## SERVICE BULLETIN

ENGINE INDICATING - ENGINE - INDICATING - ADD WASHERS AT CLIPPING POINTS CP6004 AND CP6009 - CATEGORY CODE 6 - MOD.ENG-77-0005

V2500-ENG-77-0005

Exhaust gas temperature (EGT) Harness clipping point locations  
Fig.1 (Sheet 1 of 2)

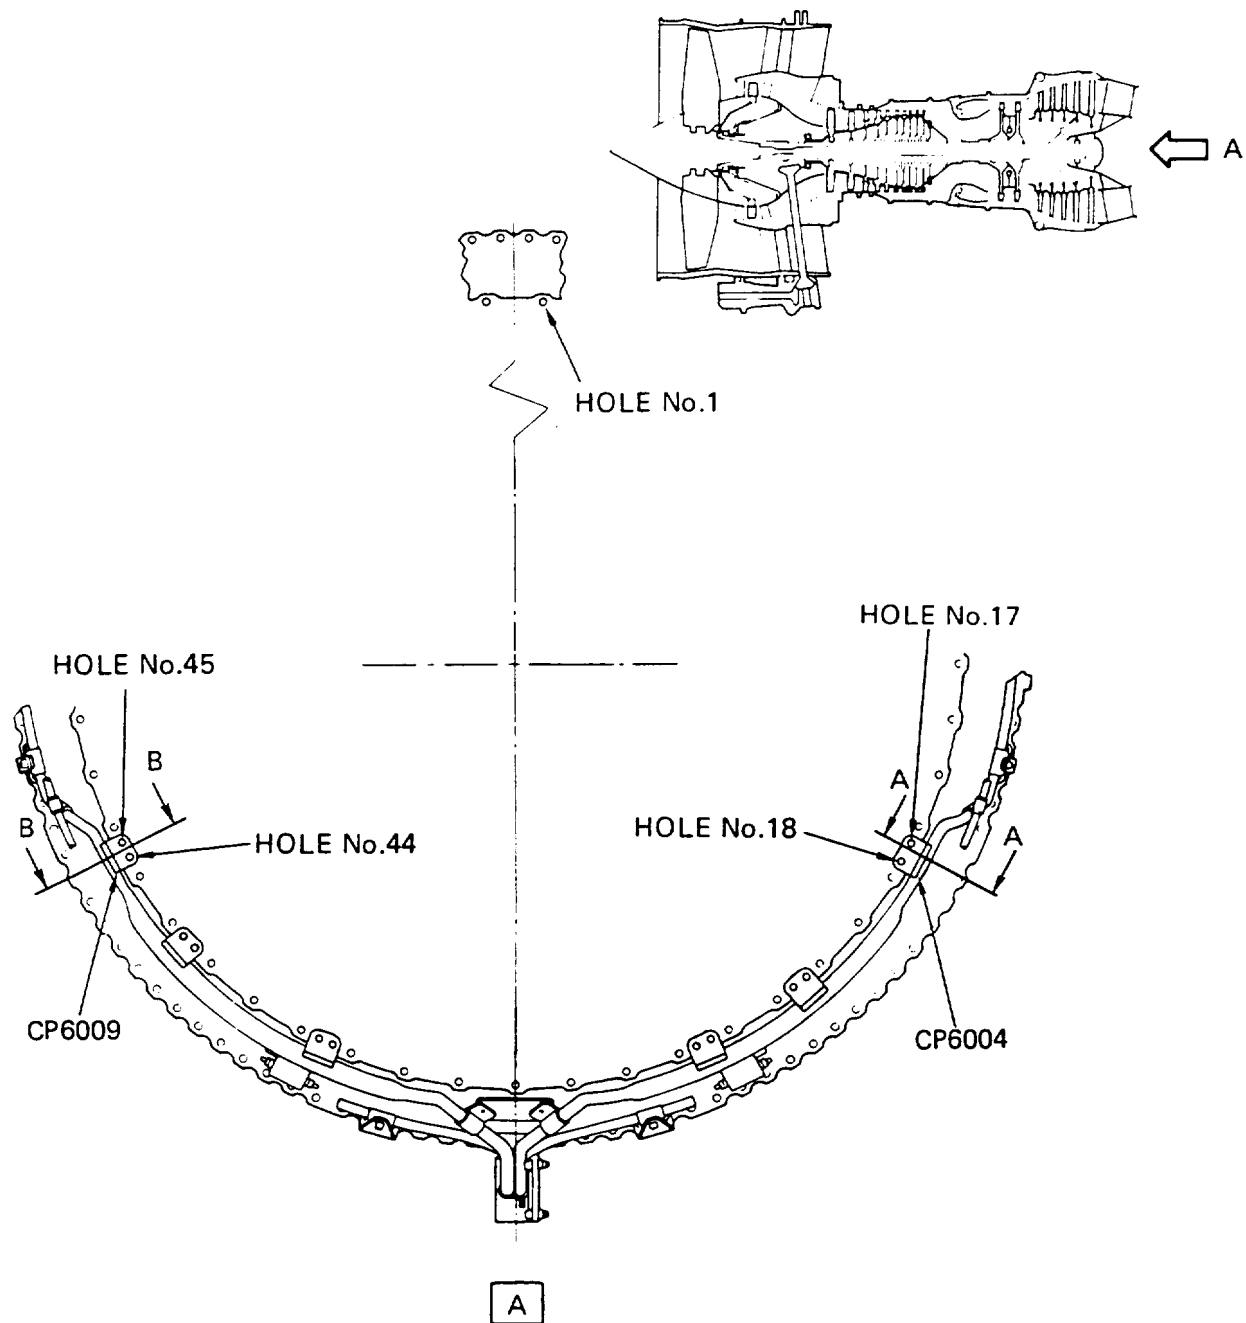
- (1) Replace the Thermocouple Box and Cable by the approved procedures in Reference (1), Chapter/Section 72-00-50 Installation-07 except:
  - (a) Install the EGT Harness Clip to the Bracket at Clipping Point CP6004 (No.17 and 18 hole locations located on Flange FT) as follows:

- (i) Lubricate the threads of the 4W0001 Nut (1 off) with CoMat 10-039 engine oil. Refer to Figure 1.
    - (ii) Install a new 347493 Washer (1 off) on the Bracket Assembly Bolt.

- (iii) Connect the EGT Harness Clip to the Bracket Assembly and Washer.
    - (iv) Install the 4W0001 Nut and tighten it with your hand.
  - (b) Install the EGT Harness Clip to the Bracket at Clipping Point CP6009 (No.44 and 45 hole locations located on Flange FT) as follows:

SECTION B-B  
CLIPPING POINT CP6009

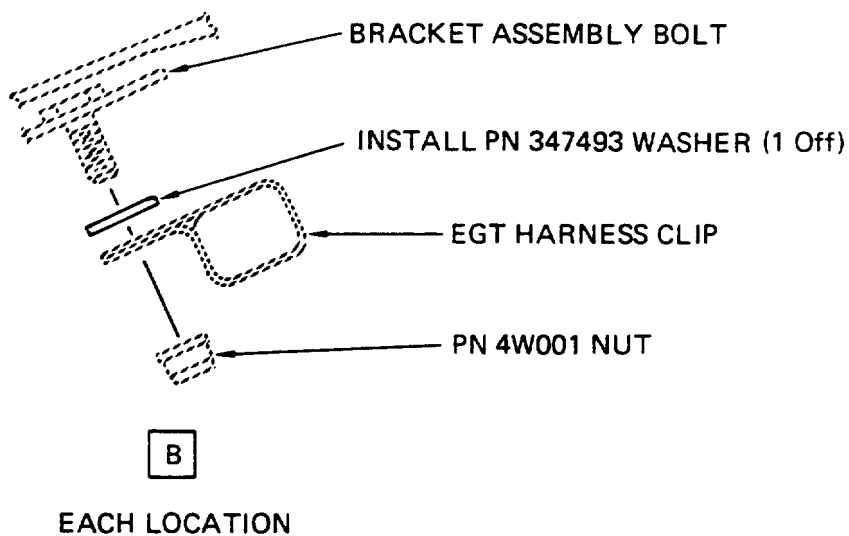
- (i) Do step (a)(i) through (iv) again.
  - (c) Torque the nuts to 36 - 45 lbfin. (4,00 - 5,00 Nm). See Reference (2), Control No./TASK No.70-41-00-400-501.
